National Association of Lift Makers

Sassi Brake Type 3040 supplied before 1st October 1993

Liftmaterial - Safety Bulletin.

**SUBJECT: PROBLEMS CONCERNING THE MANUAL
BRAKE RELEASE MECHANISM ON BRAKE TYPE 3040
FITTED ON GEARS MB 82, MB 91, MB 92, MB 94, MB 95.**

freno 3040 tav.XI

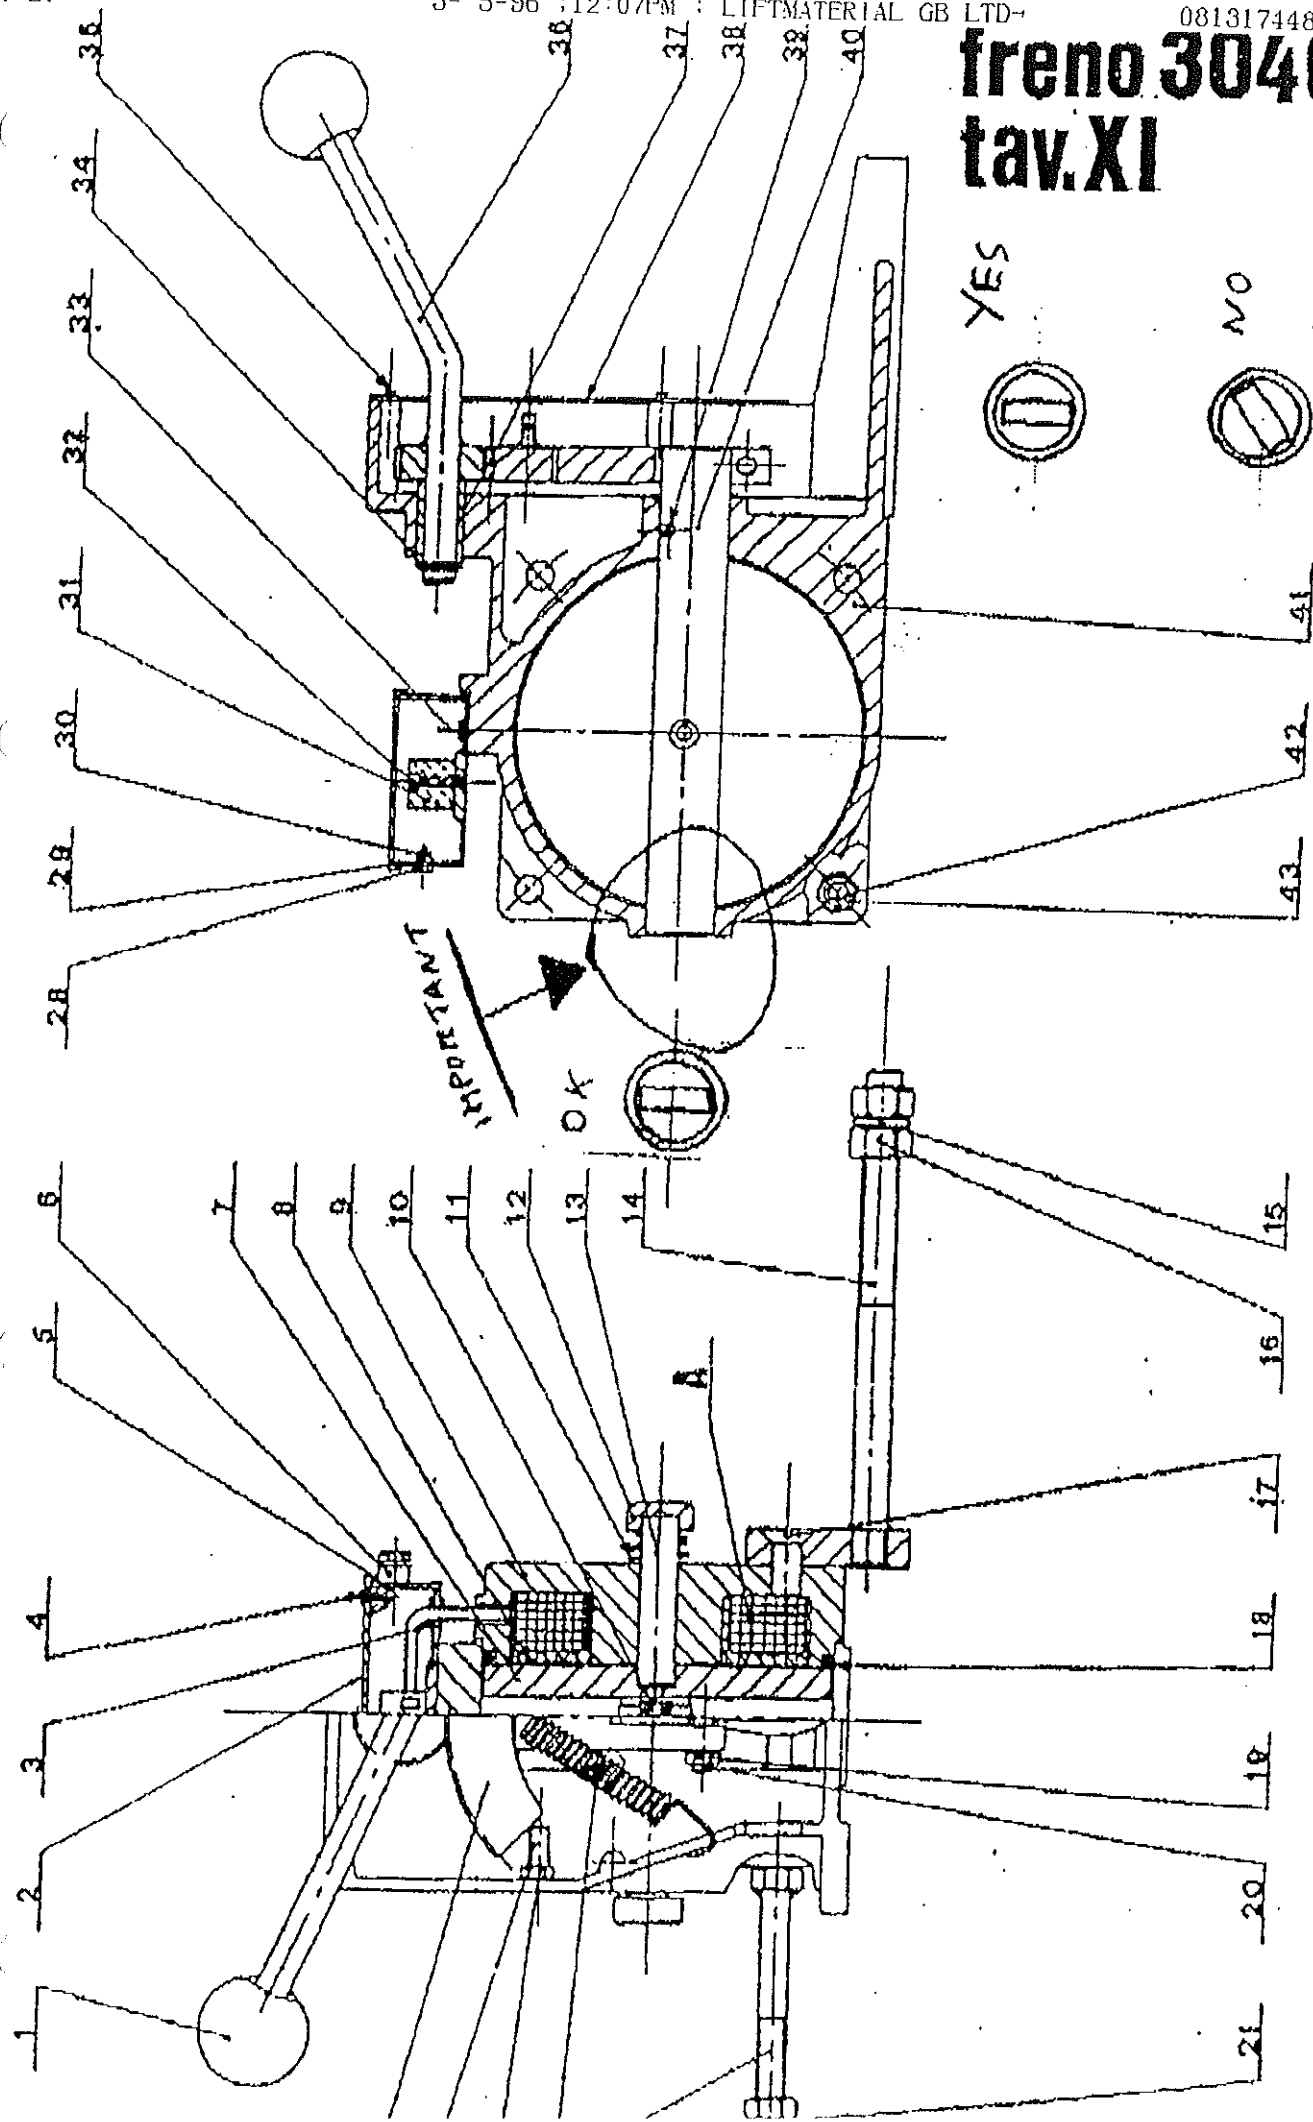
On gearboxes where the brake type 3040 is fitted and is possibly incorrectly adjusted, it was noted that if considerable excessive force was applied to the brake release arm, it was possible to mechanically jam the brake in the off position. In any case, such pressure would be greatly in excess of that normally needed to open the brake shoes with the springs already tightened to the maximum of their limit.

The above said problem is easily recognised by observing the position of the brake release lever (please see enclosed drawing).
By observing the hole it will be noticed (without touching the release handle) that the lever is either in the vertical or diagonal position. If indeed the latter is observed then the internal components of the release mechanism are deformed and must be replaced.

In the light of the SASSI policy to constantly search for improvements in its products, A. SASSI S.p.A. immediately modified the components of the manual brake release mechanism on machines fitted with brake type 3040. This modification has been effective on gearboxes supplied from the **1st October 1993**. This has solved the problem on gear units supplied since that date.

If replacement component parts are required A. SASSI S.p.A. have a component kit available through LIFTMATERIAL (GB) LTD, Braintree, to replace internal components on gear units supplied before October 1993.

Customers will need to supply information to LIFTMATERIAL (GB) of the gearbox model and the serial number, to receive the required modification kit along with the relative instructions and drawings.
